UNITED STATES PATENT AND TRADEMARK OFFICE

APPLICATION NO.	FILING DATE	FIRST NAMED INVENTOR	ATTORNEY DOCKET NO.	CONFIRMATION NO.
10/075,452	02/15/2002	Yoshikazu Takahashi	111635	8743

Office Action Summary

FIG. 3

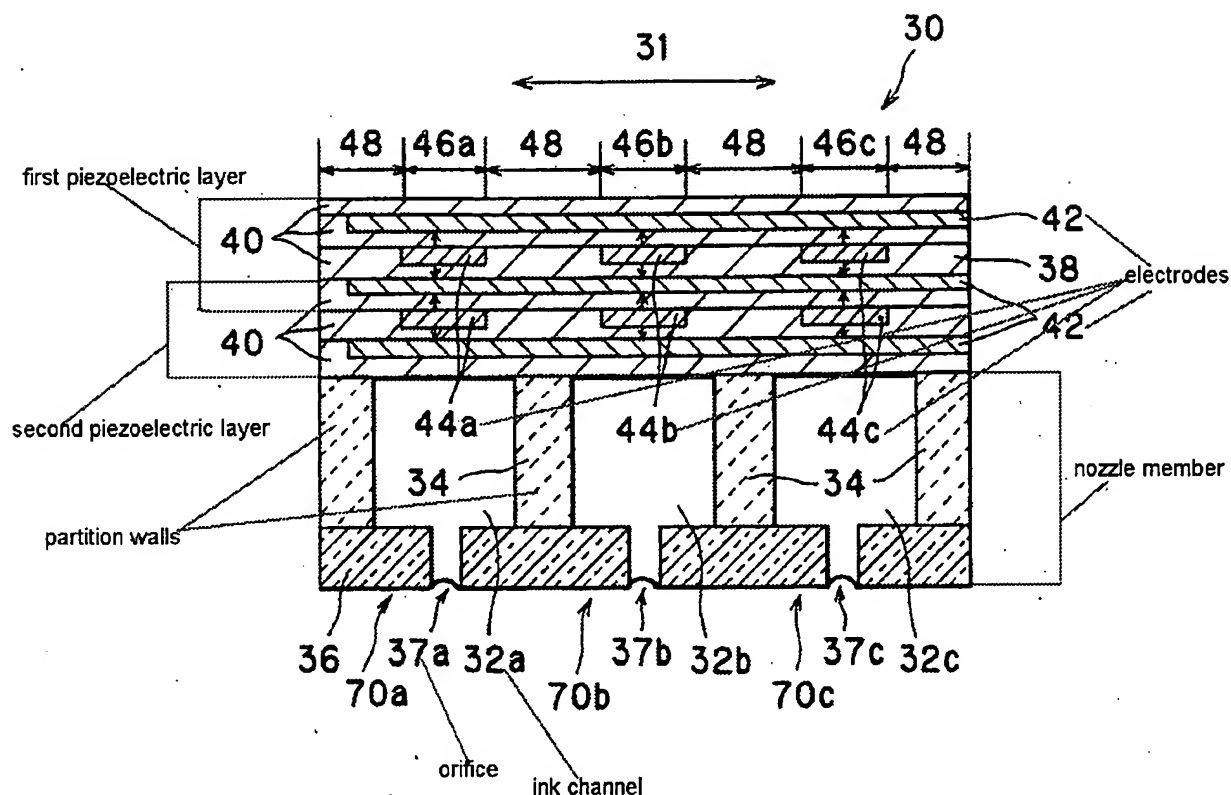
Claims 22, 23, 31, 32 are rejected under 35 U.S.C. 102(b) as being anticipated by Takahashi et al (US 5,402,159).

Takahashi et al discloses all features of the claimed invention as clearly illustrated below.
